# **LILA CANYON MINOR REVISION**

Re: UtahAmerican Energy, Inc. Horse Canyon Mine, 10-001 Resonse to Deficiencies in November 5<sup>th</sup> 2009 letter and February 4, 2010 letter.

Surface change deficiencies Task ID #3017 10-001

**Appendix 7-4  
Lila Canyon Mine  
Sedimentation and Drainage Control Plan**

FIGURE 1. HEADWATER DEPTH NOMOGRAPH

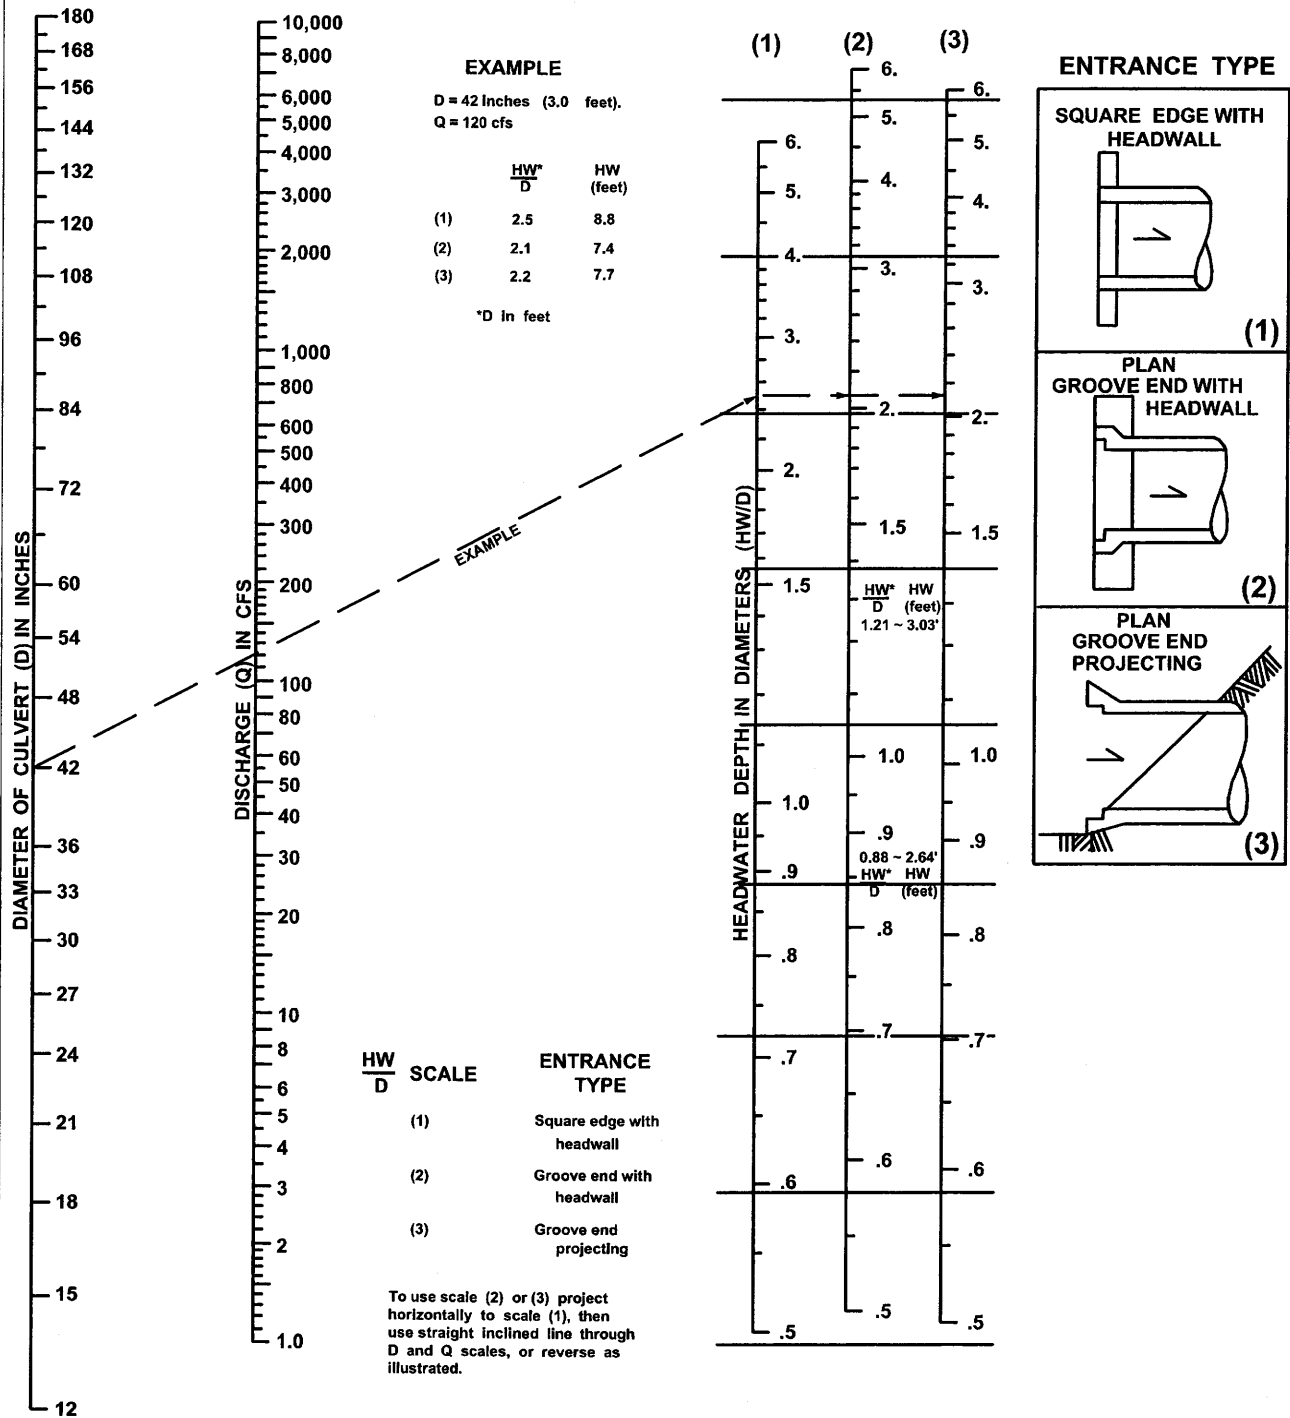
**R645-301-121.200, -150**, The Permittee must provide Figures 1, 2, 3, 4,4a, 7, and 8 in Appendix 7-4, in both the electronic and paper copies. [JDS]  
*Appendix 7-4 has been revised and submitted*

FIGURE 5

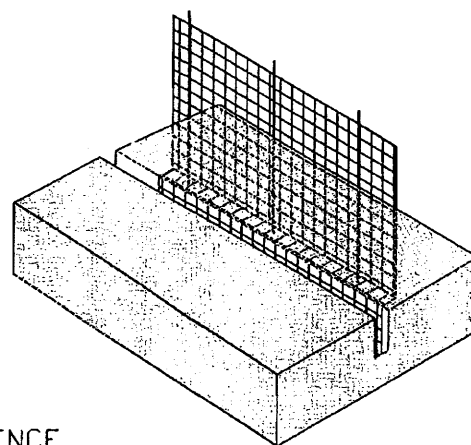
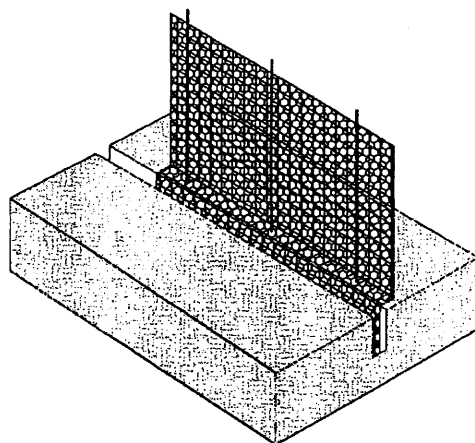
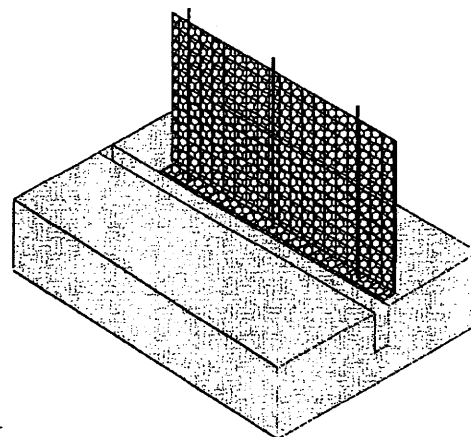
The Permittee should either provide Figures 5 and 6 or list them as "Removed" in the appropriate Table of contents of Appendix 7-4 (approximately page 41). [JDS]  
*Appendix 7-4 has been revised and submitted*
